R02-33

----- FULL TEXT OF THE PROPOSED RESOLUTION -----

PROPOSED ACCEPT IN PRINCIPLE.

Figure 148-3—PLCA Control state diagram

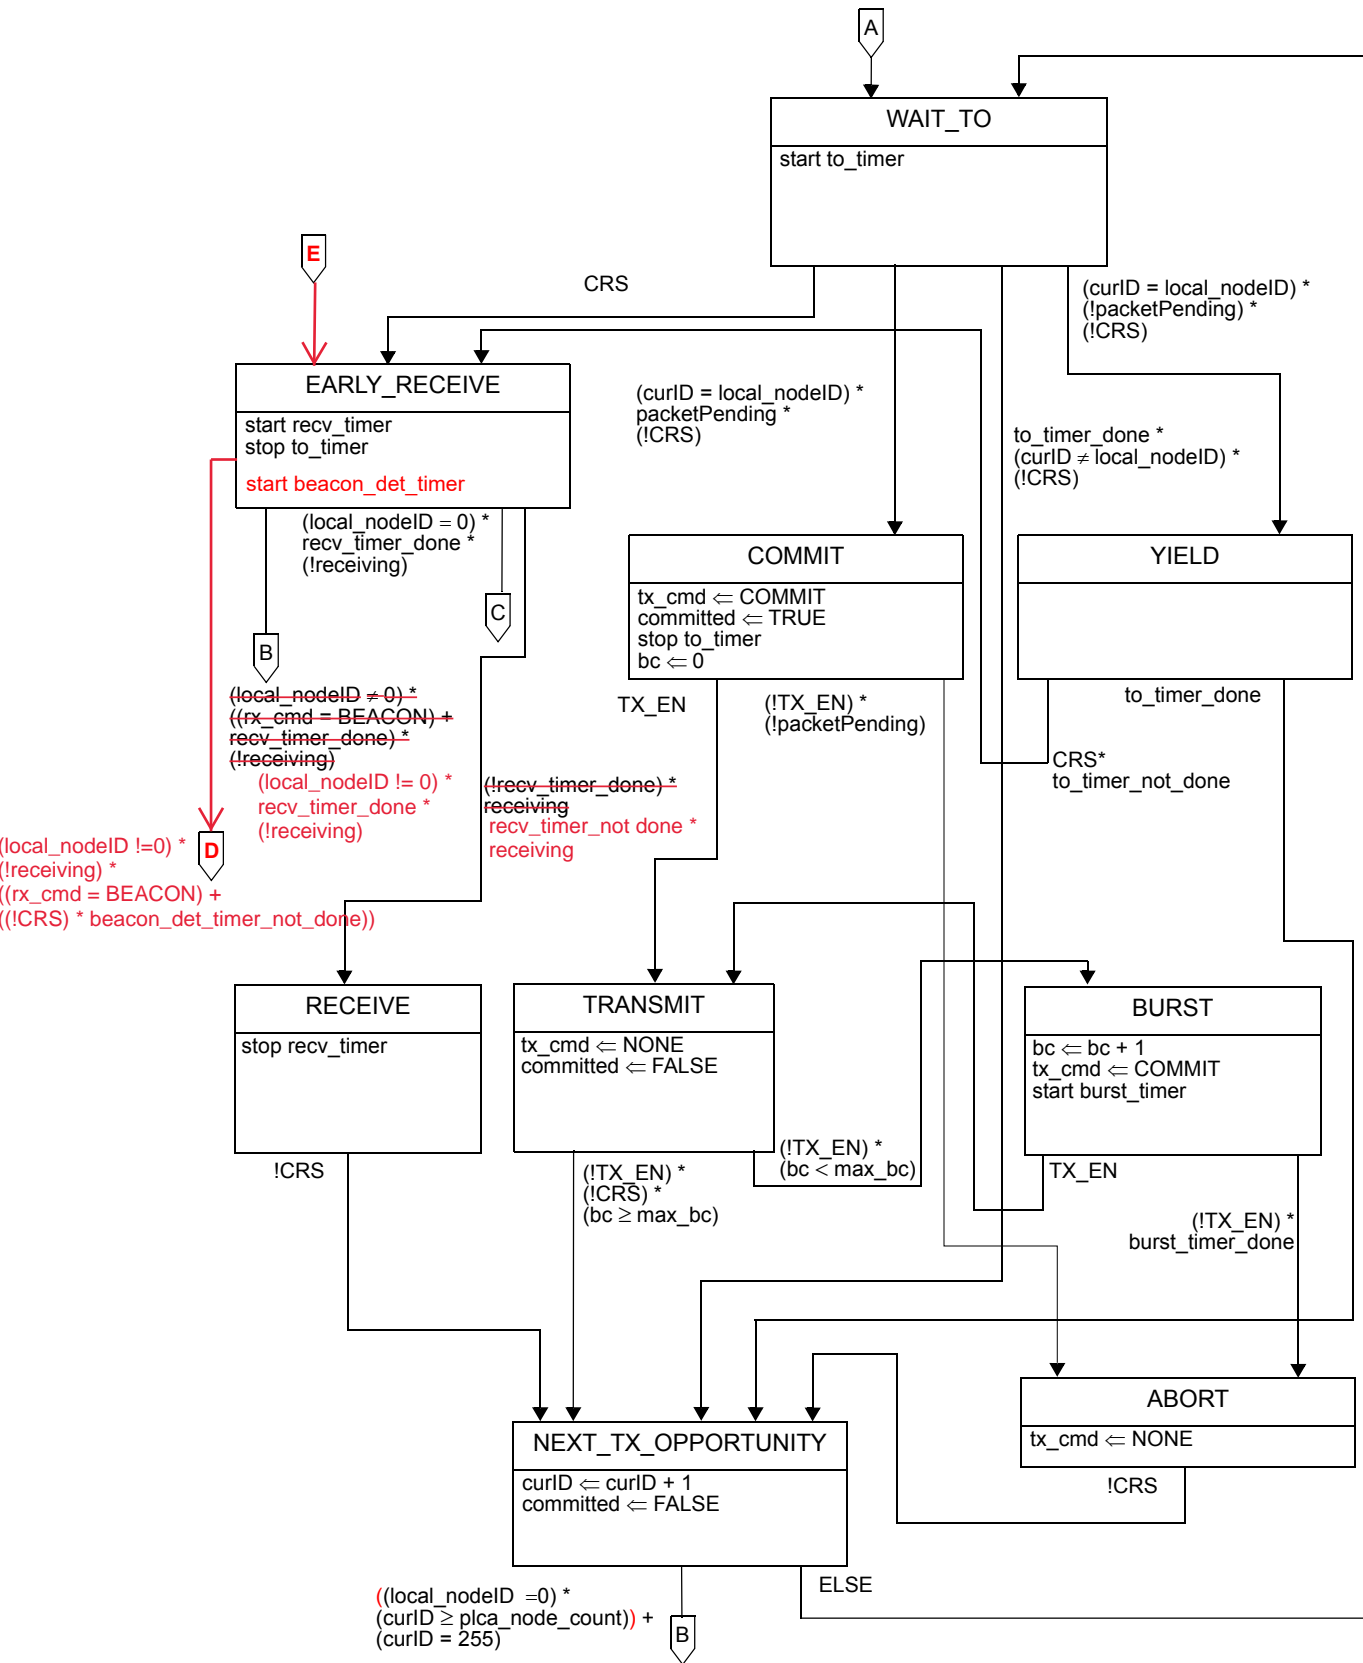
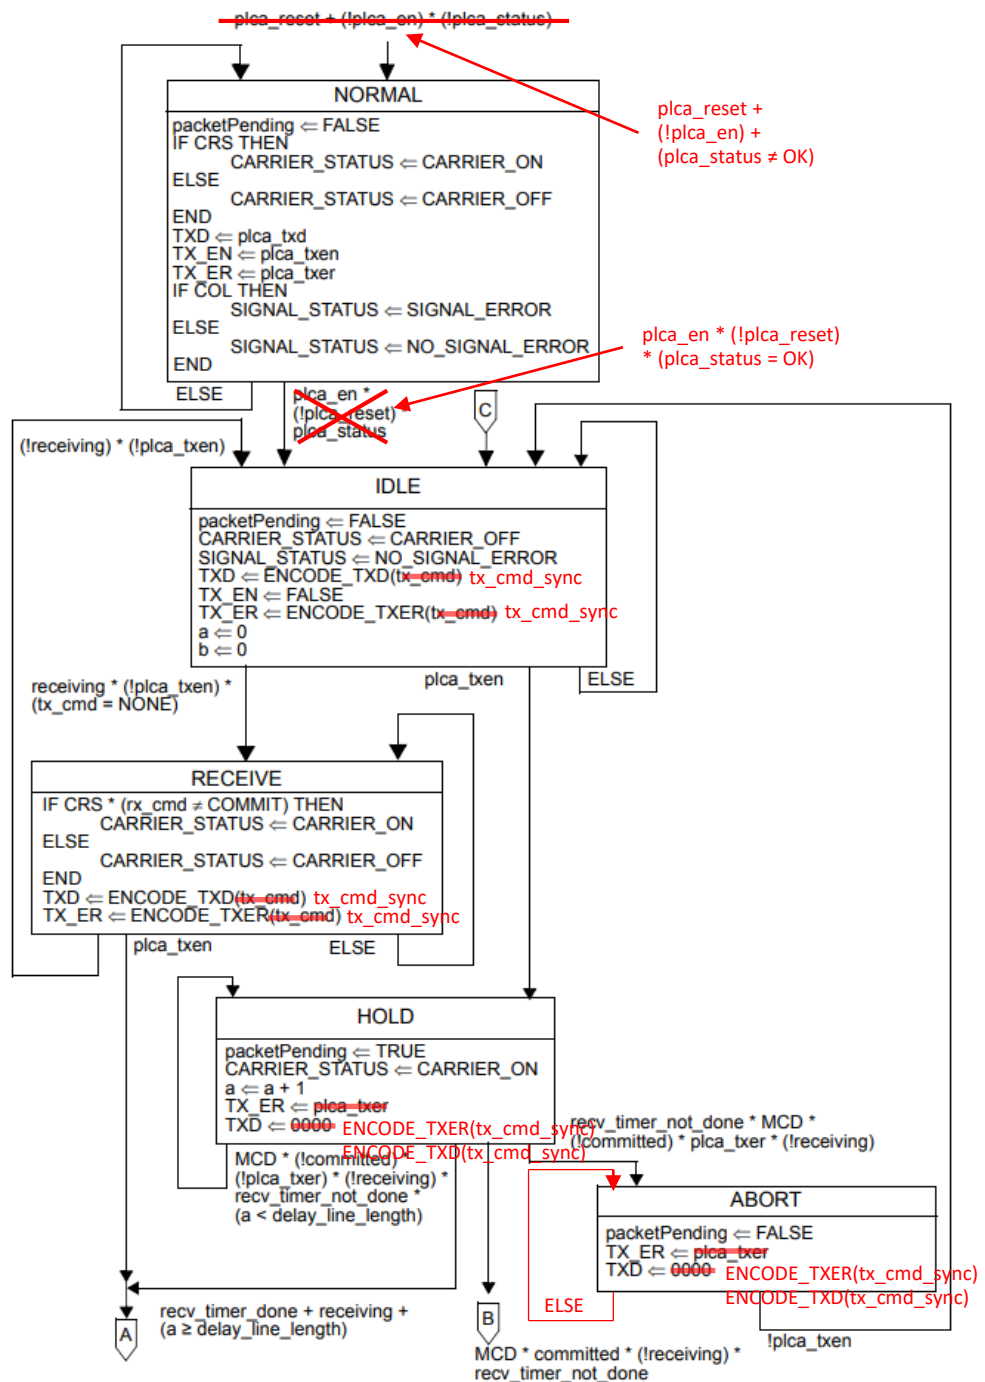
[6] At page 244 in Figure 148-3, in the transition from the RESYNC state to the SEND\_BEACON state change the condition from: "

```
local_nodeID = 0
```

[7] At page 244 in Figure 148-3, in the transition from the RECOVER

```
state to the SEND_BEACON state change the condition from: "  
    (!CRS) * recv_beacon_timer_done  
"  
to: "  
    MCD * (!CRS) * recv_beacon_timer_done  
"
```

[15] Update the PLCA Control state diagram as follows:

1. Within the EARLY\_RECEIVE state, add the action "start beacon\_det\_timer".

2. Create a transition from the EARLY\_RECEIVE state to a connector, D, with the following exit condition:

```
(local_nodeID != 0) * (!receiving) *  
((rx_cmd = BEACON) + ((!CRS) * beacon_det_timer_not_done))
```

3. Change the exit transition from EARLY\_RECEIVE to connector B from:

```
(local_nodeID != 0) * ((rx_cmd = BEACON) + recv_timer_done)
* (!receiving)
```

4. Delete the transition from RESYNC to SYNCING including its exit condition.

5. Add a connector, D, with arrow to SYNCING.

6. Within the SYNCING state, add the action:

```
IF (local_nodeID != 0) * (rx_cmd != BEACON) THEN
    start invalid_beacon_timer
```

7. For the SYNCING exit condition to connector A, replace the condition from:

8. Add an open arrow global transition to RESYNC with the condition “invalid\_beacon\_timer\_done”.

9. Add an exit transition from RESYNC to new connector, E, with the condition “(local\_nodeID != 0) \* (CRS)”

10. Add a connector, E, with arrow to EARLY\_RECEIVE.

11. Change the exit condition from EARLY\_RECEIVE to RECEIVE from:

```
MCD * (local_nodeID = 0)
```

```
(local_nodeID != 0) * recv_timer_done * (!receiving)
```

```
!CRS
```

```
recv_timer_not_done * receiving
```

Figure 148-4—PLCA Data state diagram

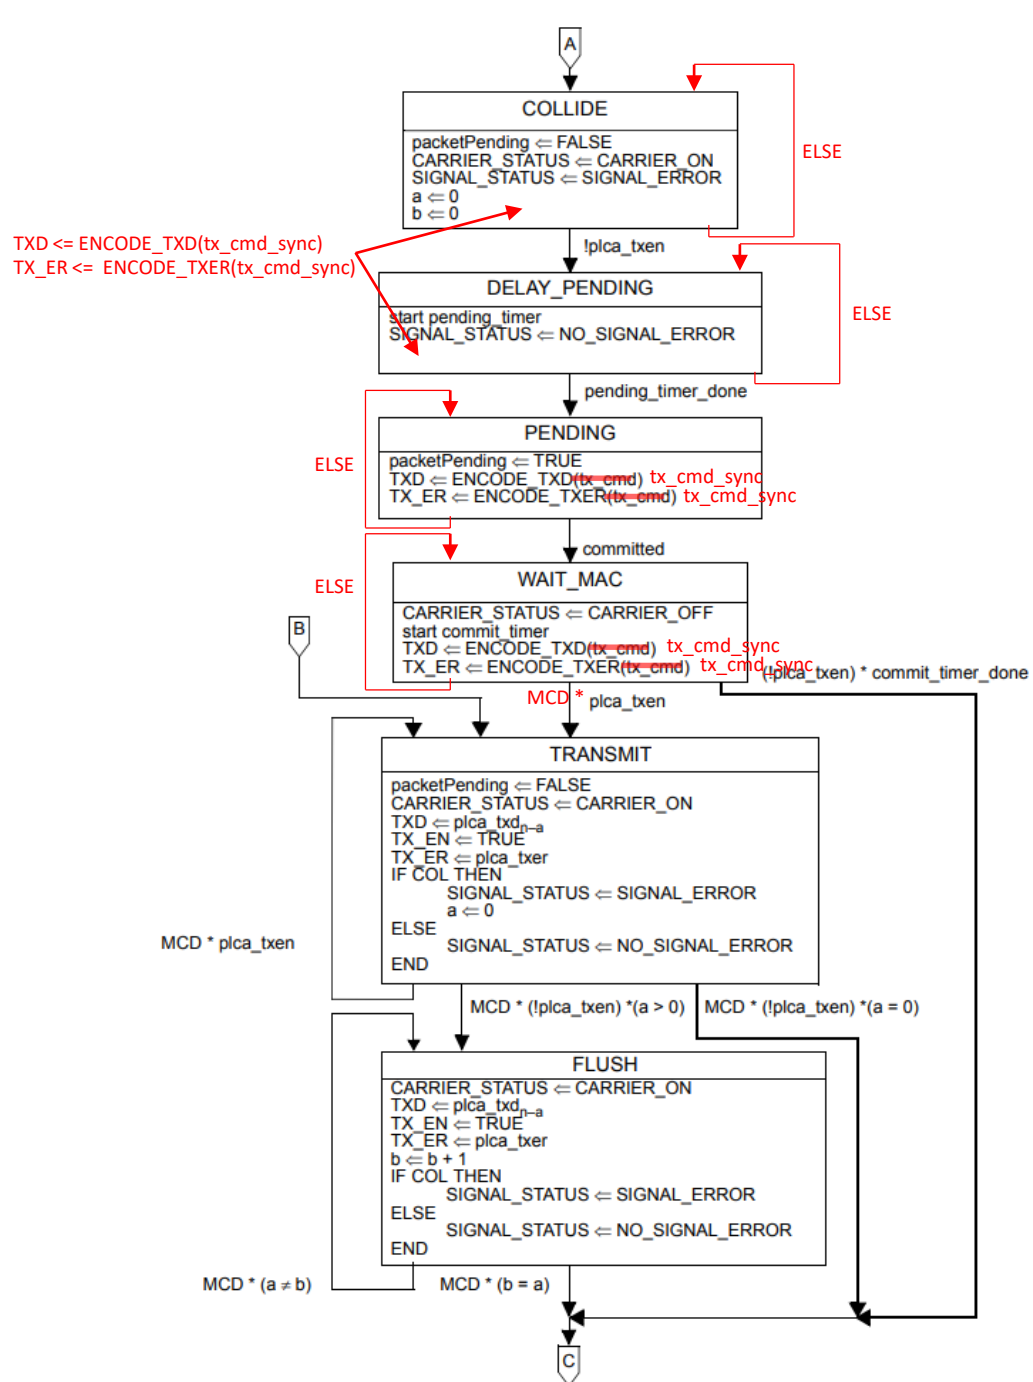
[1] In Figure 148-4, in the HOLD state, replace "

```
TX_ER <= plca_txer
TXD <= 0000
```

[2] In Figure 148-4, in the ABORT state, replace "

```
TX_ER <= plca_txer
TXD <= 0000
```

[3] In Figure 148-4, in both the COLLIDE and DELAY\_PENDING states add the following: "

```
TX_ER <= ENCODE_TXER(tx_cmd_sync)
TXD <= ENCODE_TXD(tx_cmd_sync)
```

[4] In Figure 148-4, add a recirculating arc with an "ELSE" condition to the following state boxes: WAIT\_MAC, PENDING, DELAY\_PENDING, COLLIDE and ABORT.

[5] In Figure 148-4, in the transition from WAIT\_MAC to TRANSMIT state, change the condition from "plca\_txen" to "MCD \* plca\_txen"

[11] In Figure 148-4, replace all occurrences of "ENCODE\_TXD(tx\_cmd)" with "ENCODE\_TXD(tx\_cmd\_sync)"

[12] In Figure 148-4, replace all occurrences of "ENCODE\_TXER(tx\_cmd)" with "ENCODE\_TXER(tx\_cmd\_sync)"

[13] Change the condition on the open-ended transition to NORMAL of "Figure 148-4-PLCA Data state diagram" from "  
 plca\_reset + (!plca\_en) \* (!plca\_status)  
"  
to "  
 plca\_reset + (!plca\_en) + (plca\_status != OK)  
"

[14] Change the condition on the NORMAL->IDLE transition of "Figure 148-4-PLCA Data state diagram" from "  
 plca\_en \* (!plca\_reset) \* plca\_status  
"  
to "  
 plca\_en \* (!plca\_reset) \* (plca\_status = OK)  
"

```
TX_ER <= ENCODE_TXER(tx_cmd_sync)
TXD <= ENCODE_TXD(tx_cmd_sync)
```

```
TX_ER <= ENCODE_TXER(tx_cmd_sync)
TXD <= ENCODE_TXD(tx_cmd_sync)
```
